RECOMMENDATIONS OF THE NUCLEAR REGULATORY COMMISSION ADVISORY COMMITTEE  
ON REACTOR SAFEGUARDS REGARDING THE MARCH 28, 1979 ACCIDENT AT  
THE THREE MILE ISLAND NUCLEAR STATION UNIT 2

Presented orally to, and discussed with, the NRC  
Commissioners during the ACRS-Commissioners Meeting  
on April 17, 1979 - Washington, D. C.

EXTRACT OF B&W COMMUNICATION - RECEIVED BY NRC  
4/20/79

Figure 1

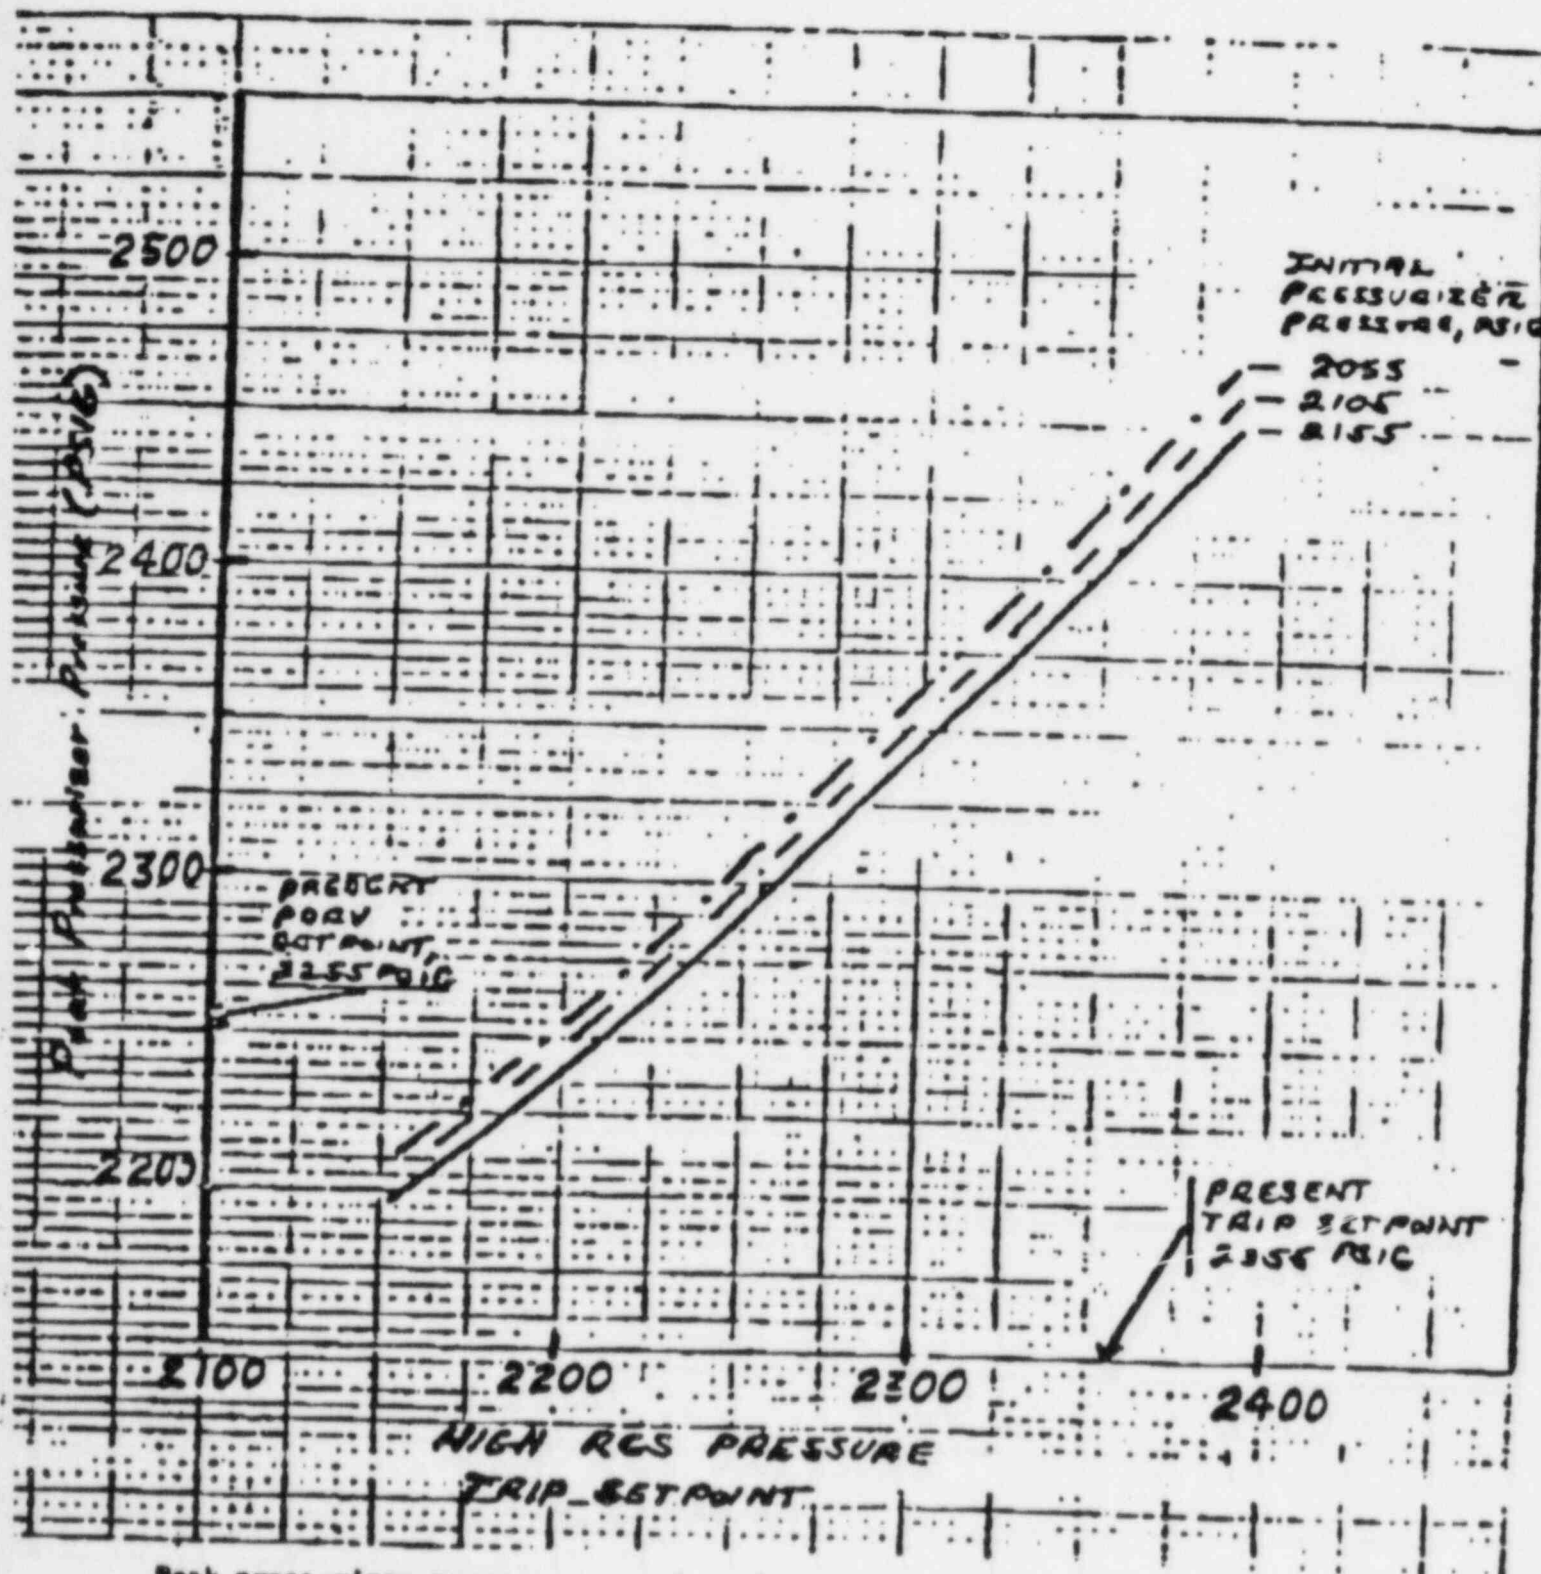
The effect of changing the reactor coolant system pressure trip setpoint upon peak pressurizer pressure is typified by the attached figure 1, which was developed by B&W for a loss of feedwater transient.

LOWERING THE HIGH PRESSURE REACTOR TRIP SETPOINT FROM 2355 PSIG TO 2300 PSIG

RAISING THE SETPOINT FOR THE PILOT OPERATED RELIEF VALVE FROM 2255 PSIG TO 2450 PSIG
